AMENDMENTS TO THE DRAWINGS

ZHANG et al.
Appl. No. 10/813,131
January 24, 2006

Fig. 2 (PRIOR ART)

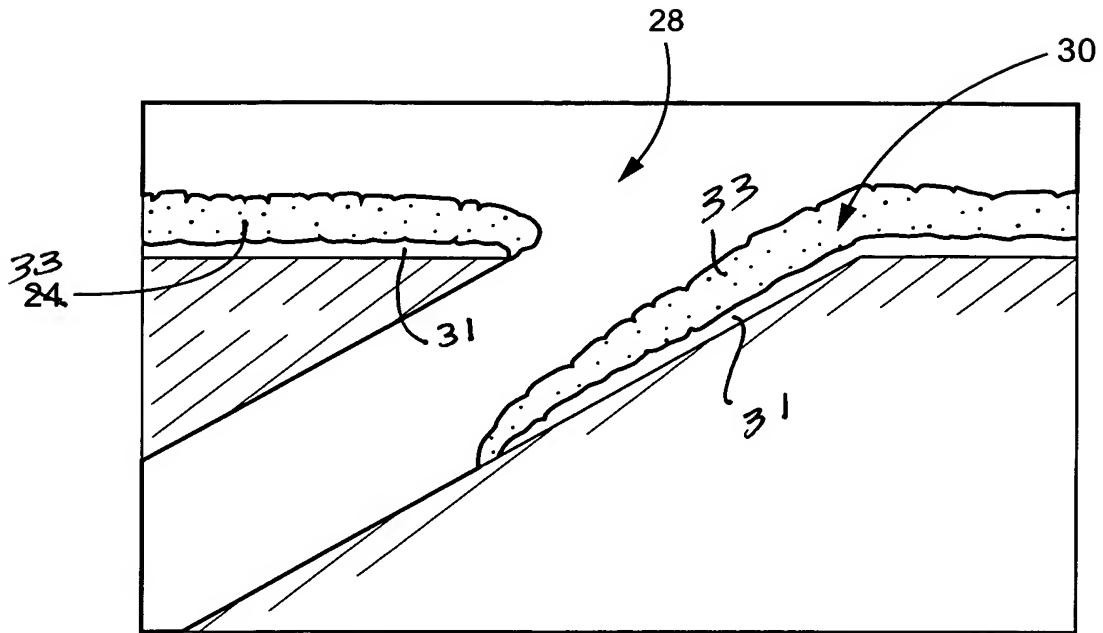
The Examiner has objected to the drawings for failing to disclose both the first bond coat layer and second bond coat layer as called for in claims 4-6, 9 and 10-12.

Applicants have submitted herewith a new sheet 2 incorporating amended Figures 2 and 3 with reference numerals indicating both the bond coat and ceramic top coat in Figure 2. In addition, Figure 2 has been labeled, "Prior Art" as required by the Examiner.

The attached sheet of drawings includes changes to Figs. 2 and 3. The sheet replaces the original sheet 2 of the drawings as filed.
